233124 PSC Modifications
Imperial Oil Resources Limited

DOCUMENT TITLE: RFI – NPS 26 FROTH BEND SPOOL

Subject: NPS 26 Froth Bend Spool

SP-K3493

Figure 3: A1-18001 Test assembly comparison sketch

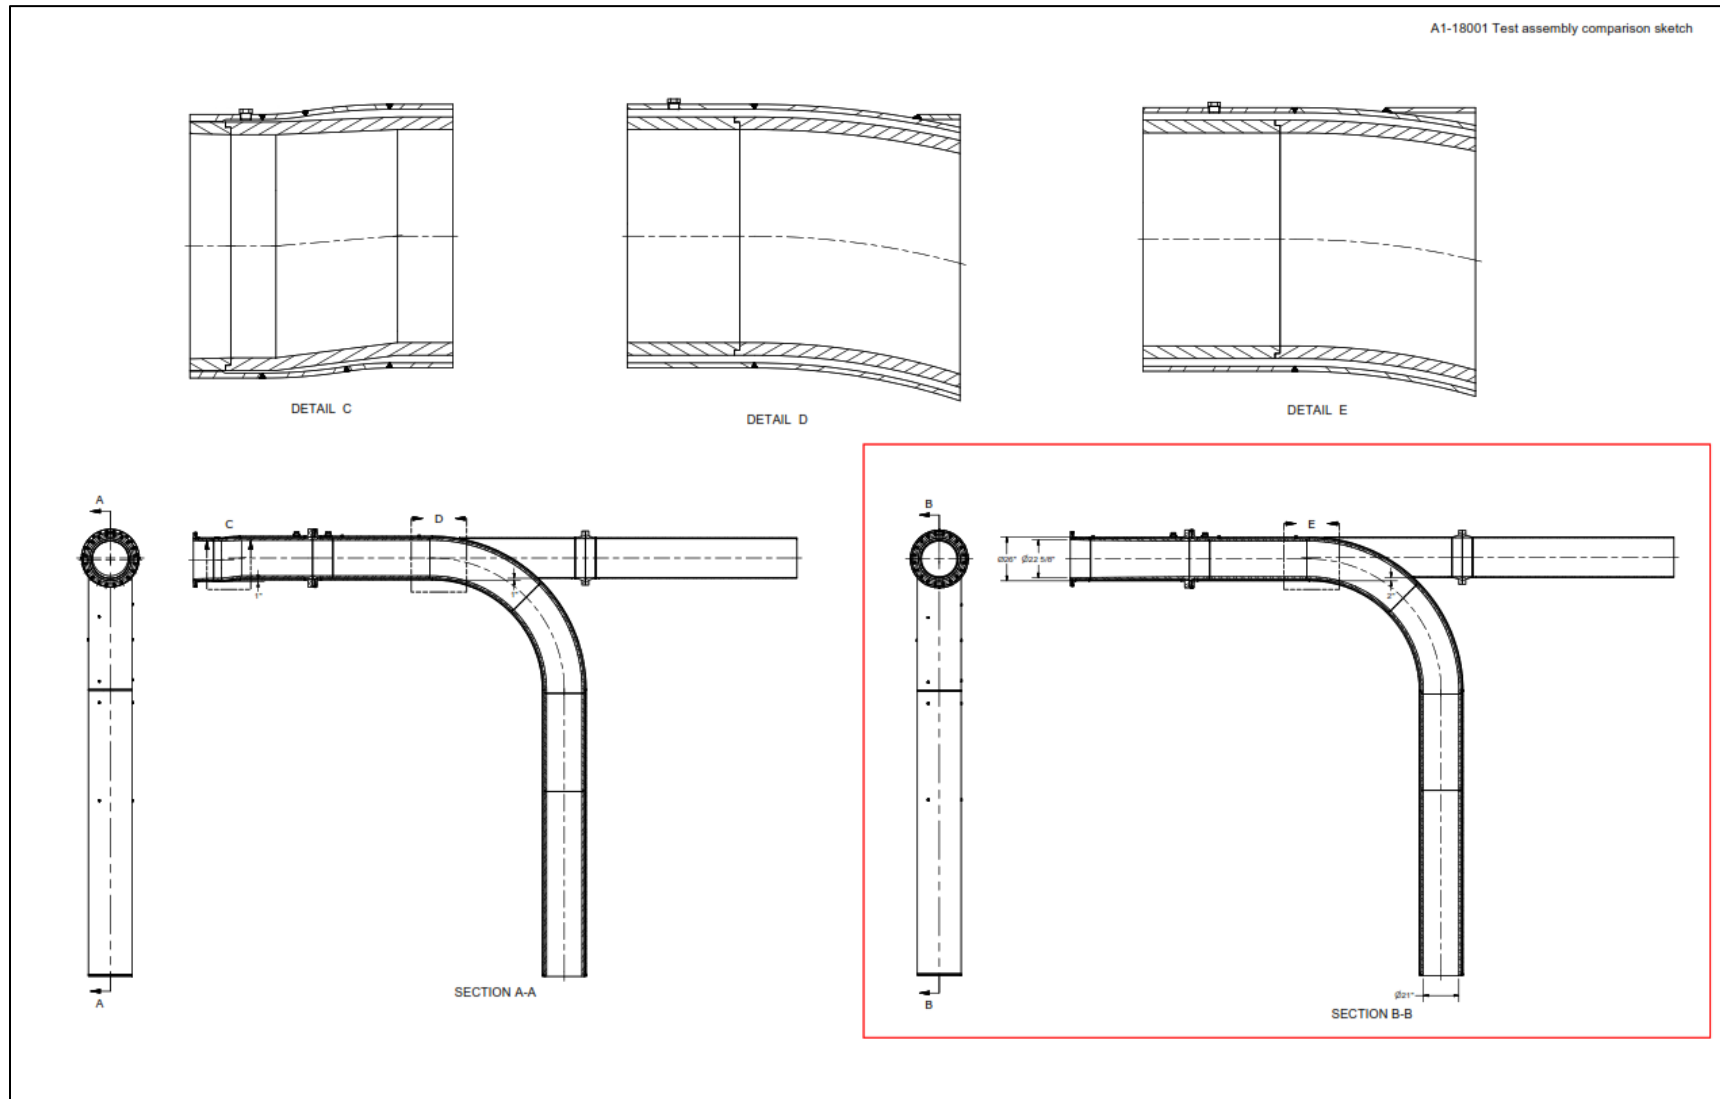
Using a forged fitting 26" XS 3D 90 DEG ELBOW ASTM A234 WPB in lieu of the induction bend called for on the drawing, the supplier needs a $\frac{3}{4}$ " gap between the OD of the liner and ID of the pipe fitting. With the $\frac{3}{4}$ " gap, the ID of the 26" froth bend spool will be 21". See attached sketch "A1-18001 Test assembly comparison sketch" (*Figure 3*), on the bottom right corner boxed in red. This is the option the supplier proposes to keep the NPS 26 pipe. Supplier requests if this option with the forged fitting and 21" ID of the liner is acceptable.

The proposed solution as shown in Figure 3 (Section B-B shown in red box) is acceptable. Velocity in the bend section is marginally increased from 1.45 m/s to 1.6 m/s due to the increased liner gap. There is no impact to Pump hydraulics (See Attachment -1).

Please ensure the following changes are captured by all affected parties and affected changes are reflected in all engineering deliverables:

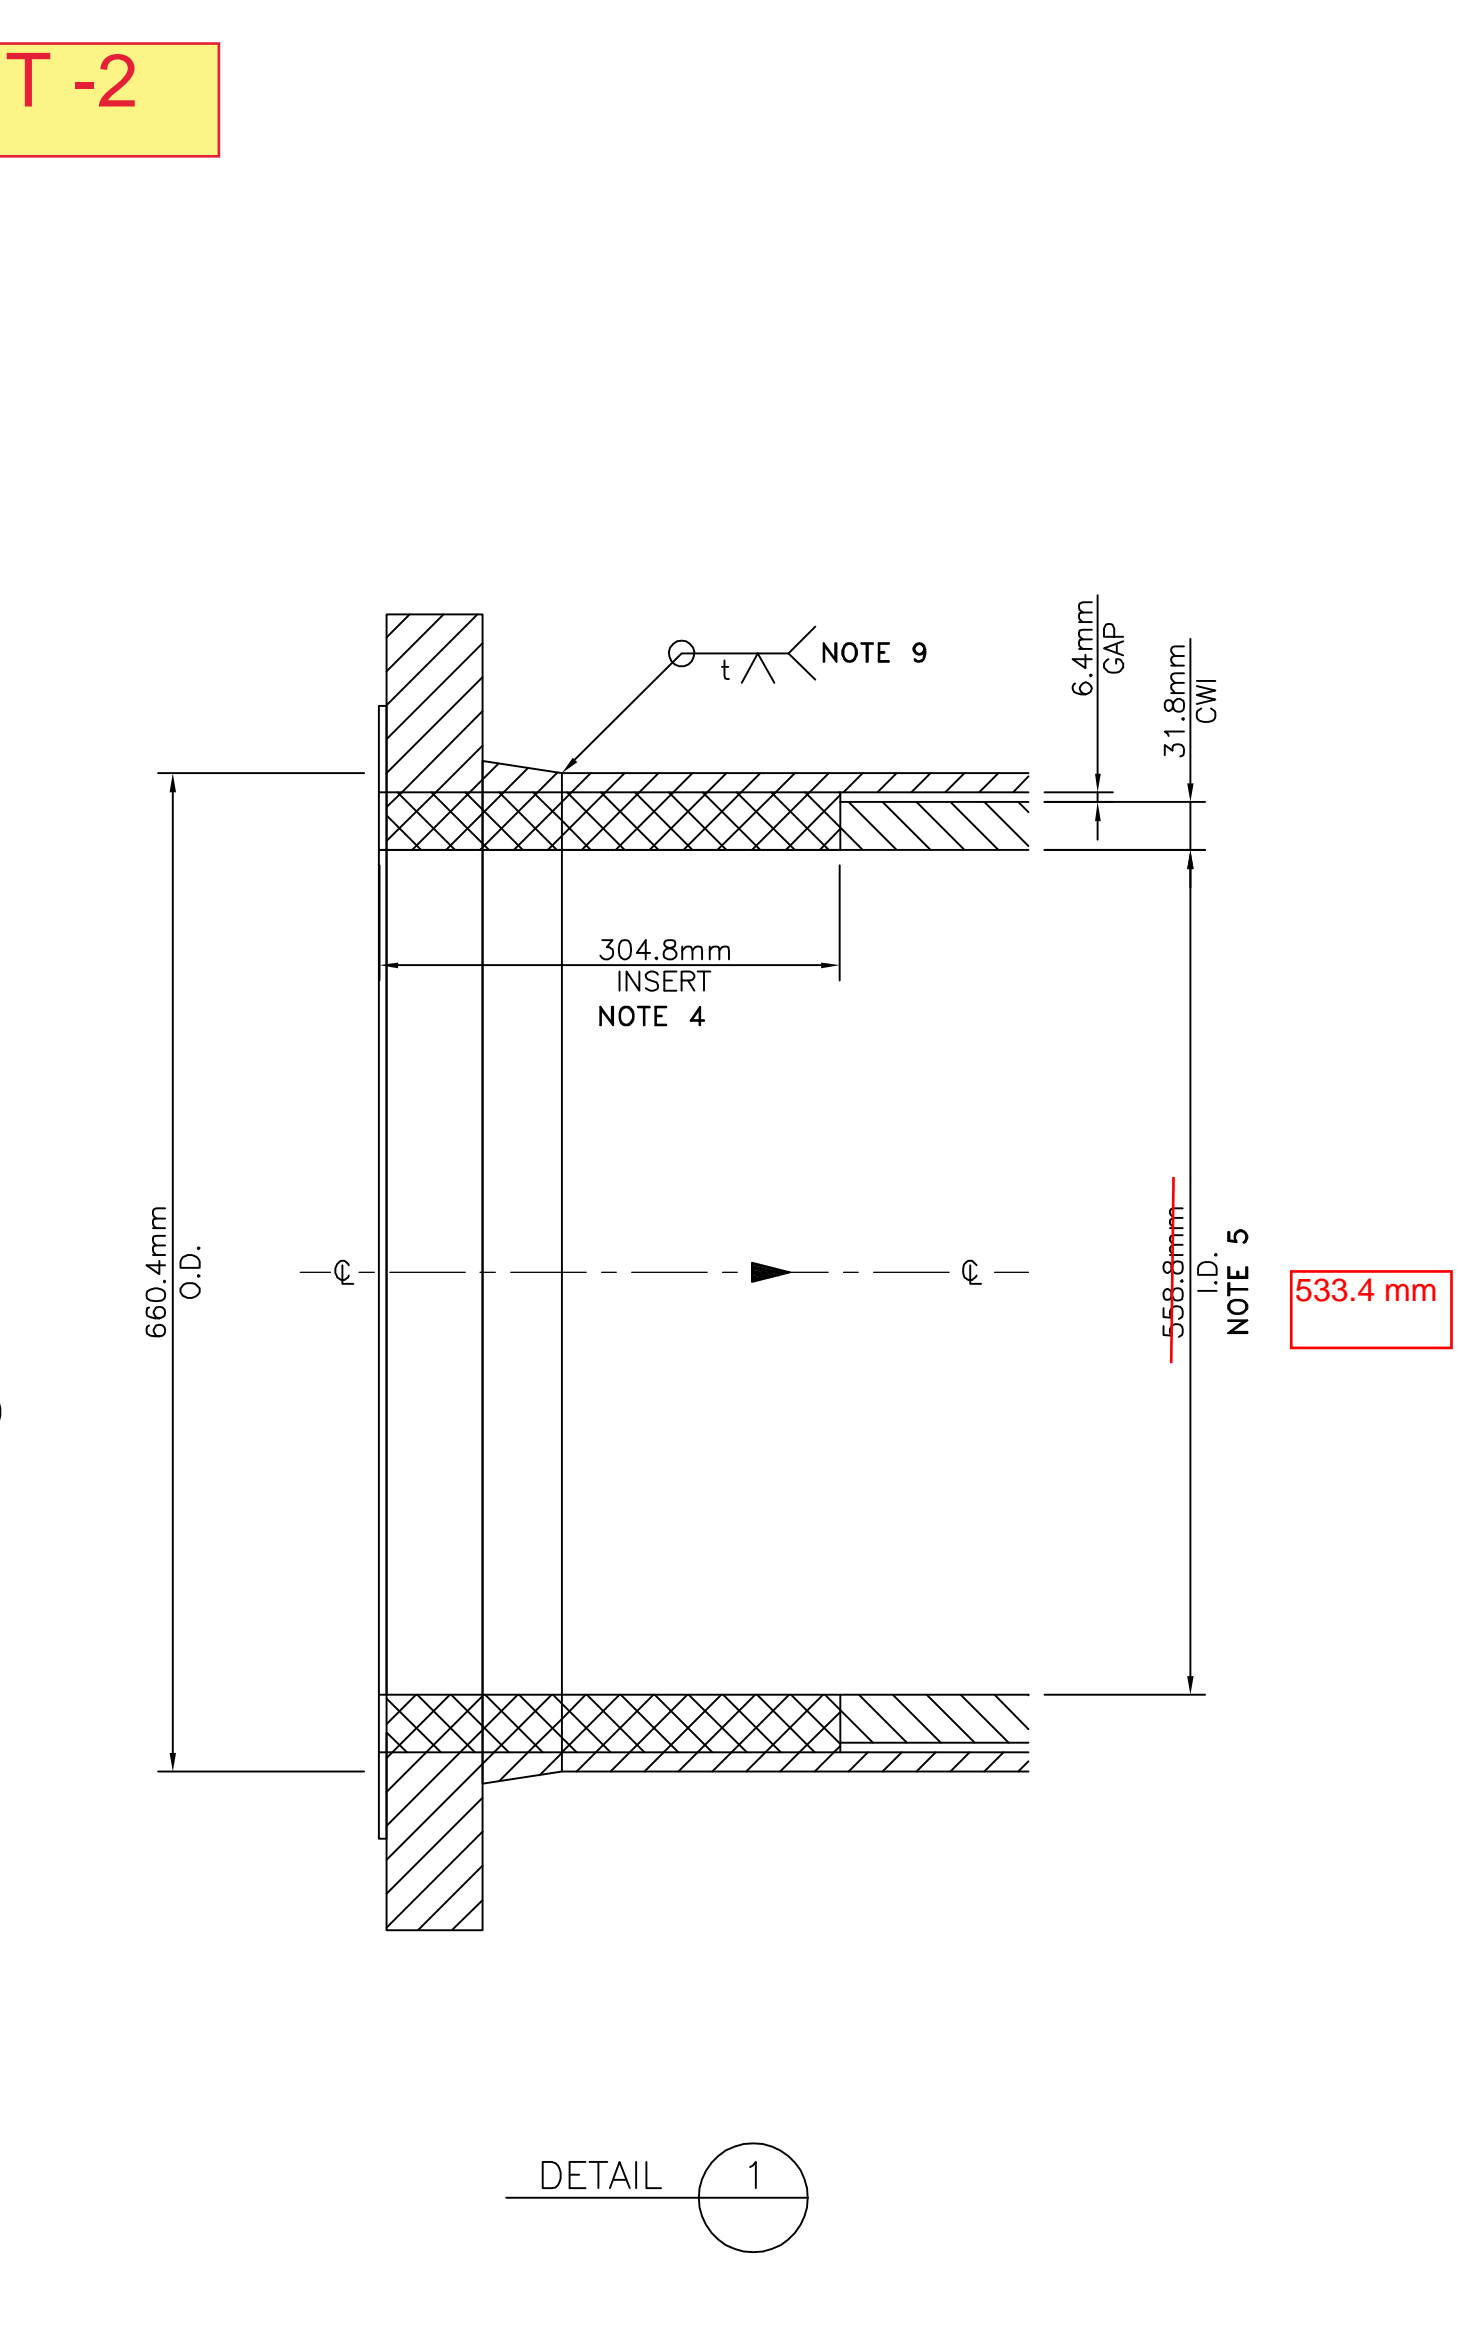
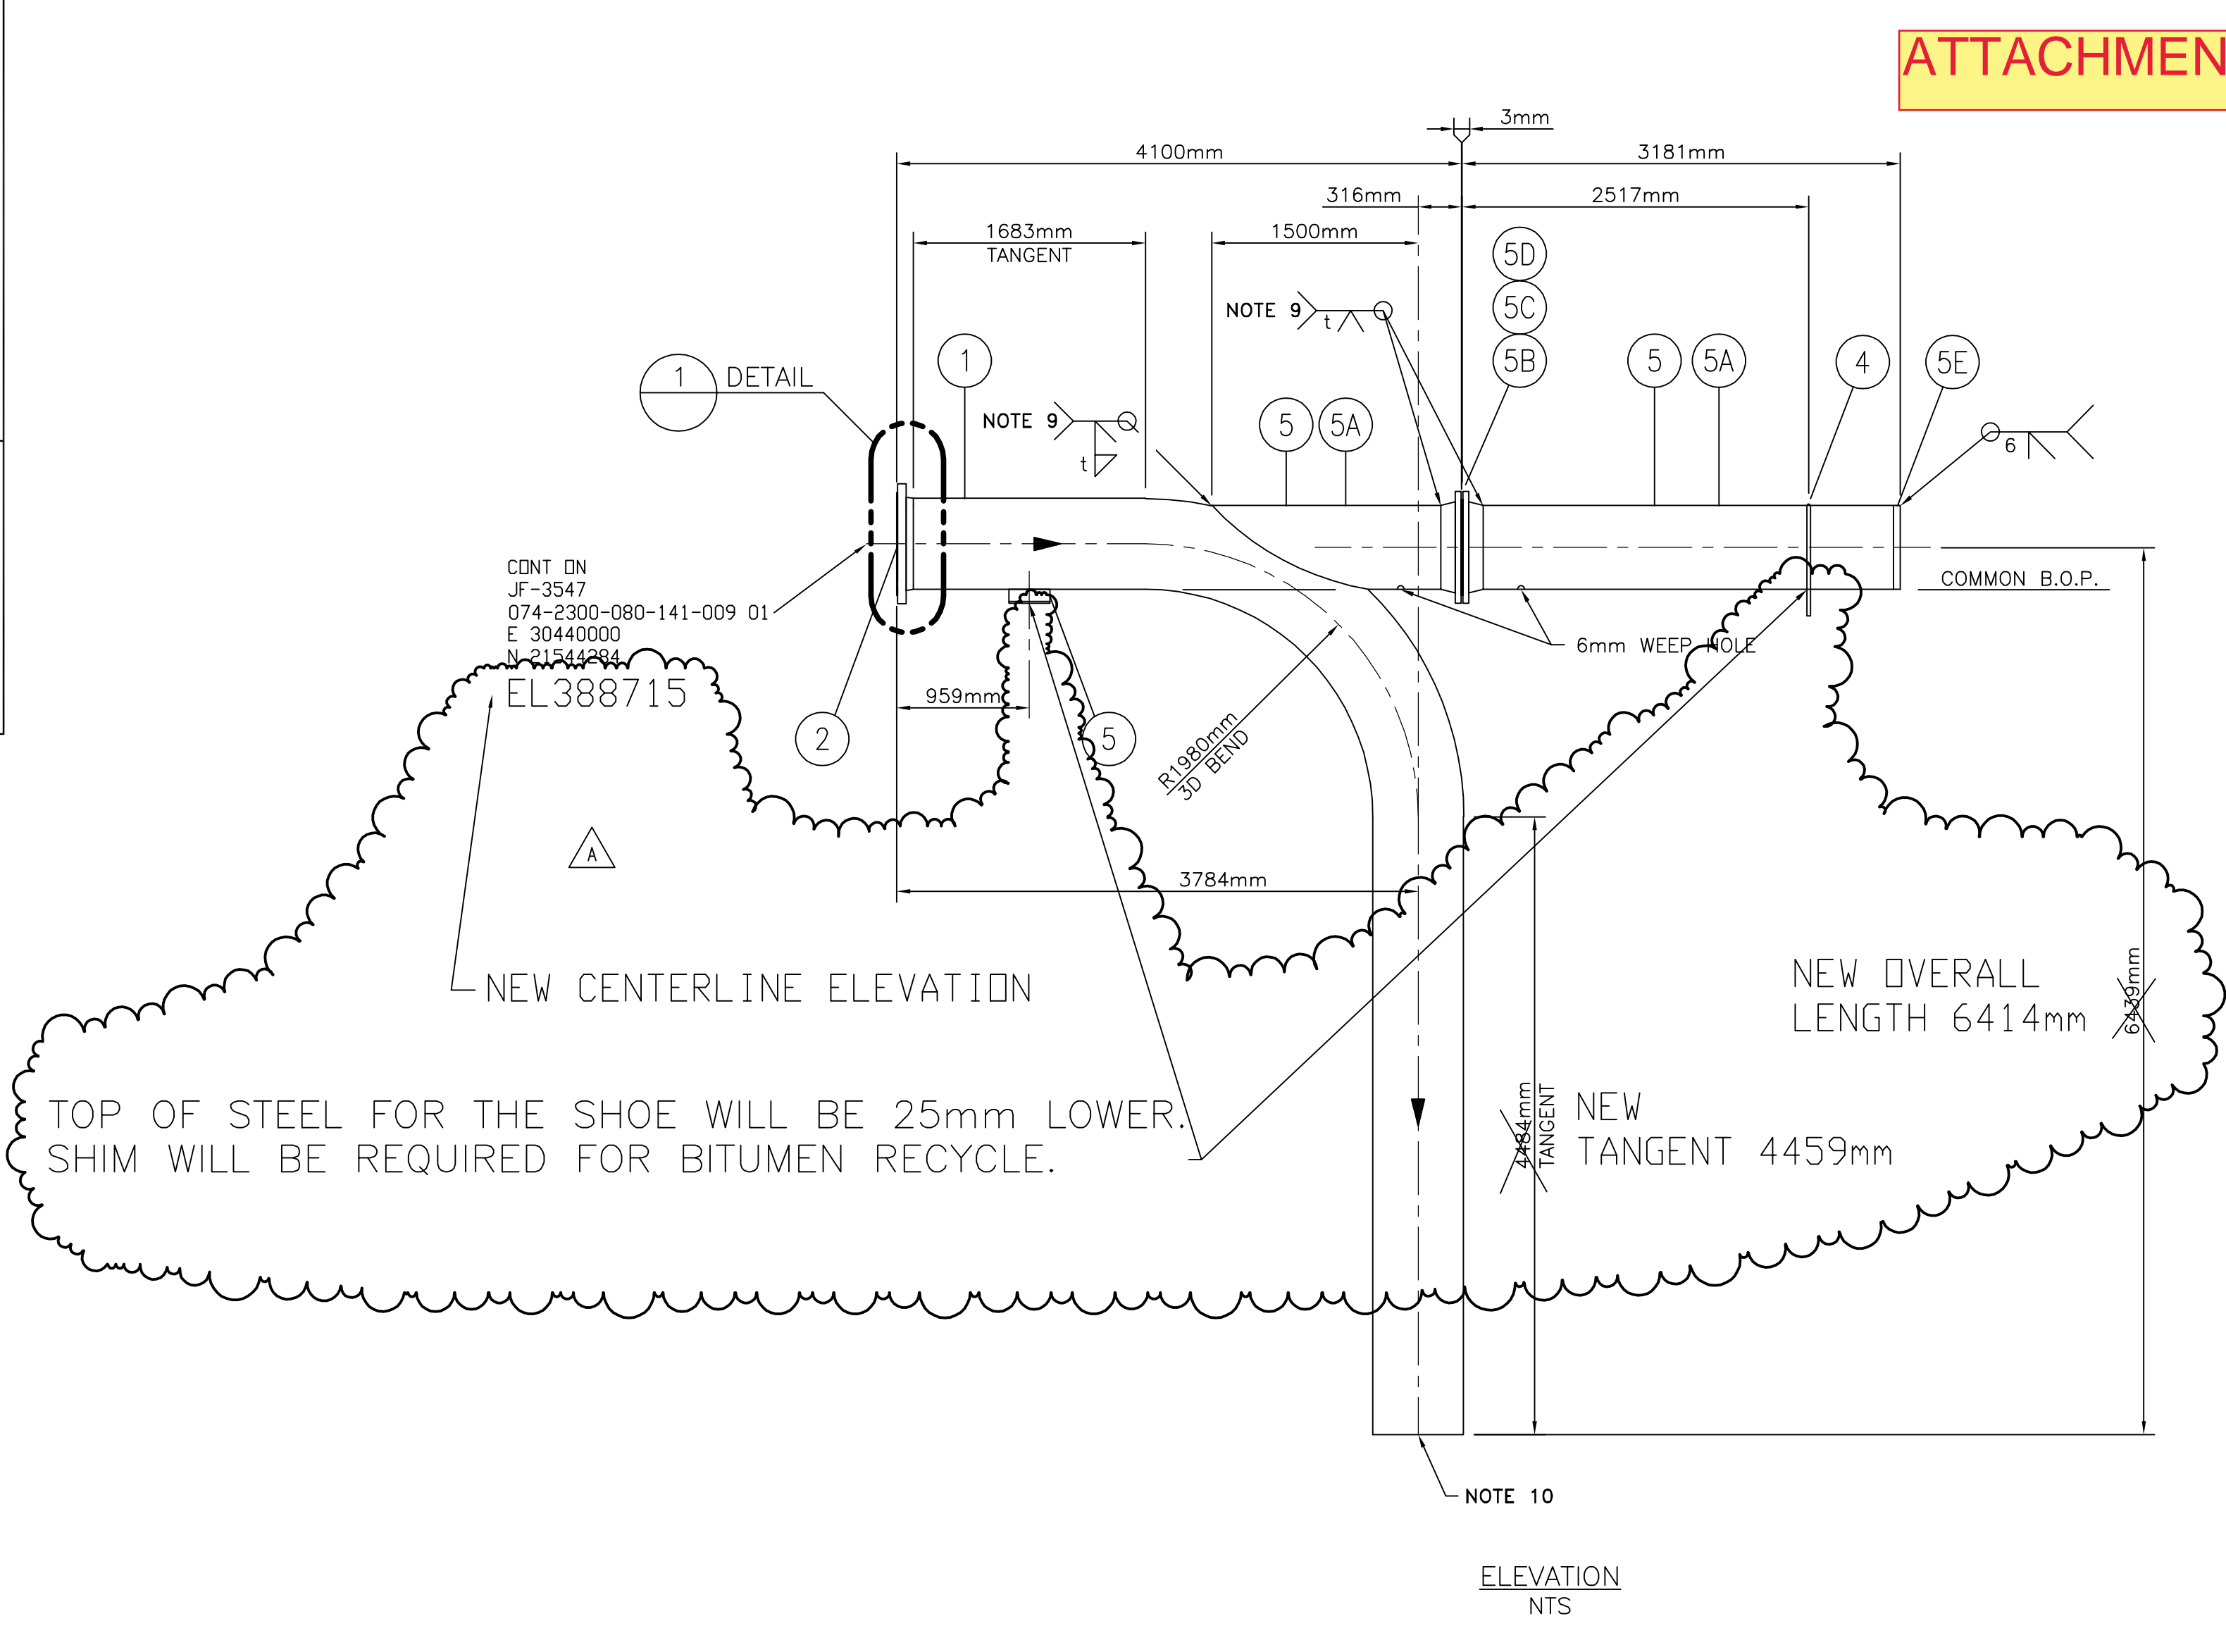
Reason for increasing pipe diameter on the 26" bend spool shown on WP drawing 074-2300-080-141-010 01 Rev 0 (*Figure 2*) is for the following reason: supplier needs 1- $\frac{1}{4}$ " gap between OD of liner and ID of pipe induction bend of this radius. Drawing 074-2300-080-141-010 01 Rev 0 show a $\frac{1}{4}$ " gap on this bend spool, which works on straight pipe, but is not big enough for the bend.

Due to CWI liner construction constrains for forth line bend spool, vendor has proposed attached changes. Please let me know if this is acceptable. In new design ID of pipe will be changed from 558.8 mm to 533.4 mm. Narjeet is also interested to know the velocity change between both cases.

Is this acceptable from stress and piping design point of view? There is no change in CWI thinnkness.

- 1) Pipe support elevation (TOS elevation) needs to be lowered as per changes reflected in the attached drawing 074-2300-080-141-010 01. (Attachment - 2)
- 2) Overall Length of bend spool is changed as per attached drawing 074-2300-080-141-010 01 (Attachment - 2)
- 3) Pipe support loads at support locations have changed as per the stress sketch attached (Attachment - 3)
